PRELIMINARY INFORMATION

Subject: Intermittent Clutch Pedal Low or Pedal Does Not Fully Return After Being Depressed

Models: 2010-2011 Chevrolet Camaro
Equipped with Manual Transmission RPO MV5 or M10

2662527

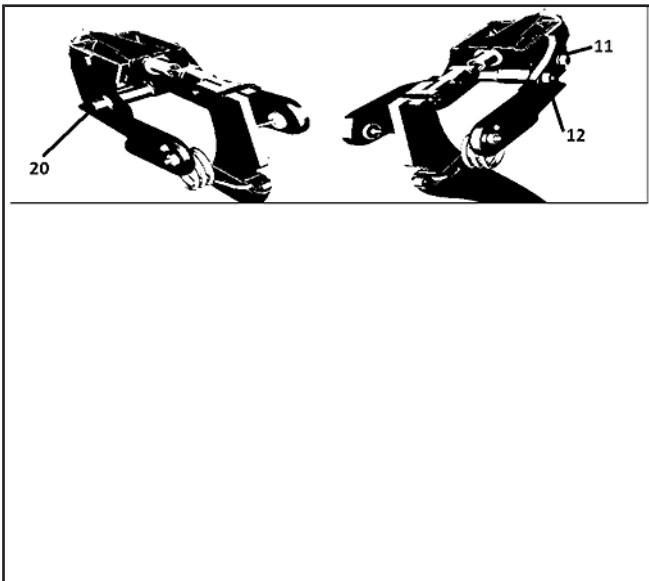
Some customers may comment on a low clutch pedal or that the clutch pedal does not fully return to the top after being depressed. This condition typically occurs when operated for the first time of the day and the transmission is cold.

Reposition the clutch master cylinder.

1. Loosen the nut (12) and bolt (11) on the pedal assembly on the right side and the bolt (20) on the left hand side of the pedal assembly that the clutch master cylinder attaches to.
2. Once all the bolts are loose, pull up on the pedal and secure the pedal to the steering wheel in fixed top of travel position with a bungee strap. Ensure that the steering wheel is not scratched or damaged by placing a rag or towel around it. This allows the master cylinder to move approximately 1.5 mm rearward in vehicle.
3. Tighten the bolt (20) first to 15 N·m (11 lb ft) and then while holding the bolt (20), tighten the nut (12) to 12 N·m (9 lb ft).

4. Lastly, tighten the bolt (11) to 12 N·m (9 lb ft) and remove the bungee strap.

Due to the movement of the clutch master cylinder, the clutch pedal resting position may move slightly; about 6 mm above the brake pedal.
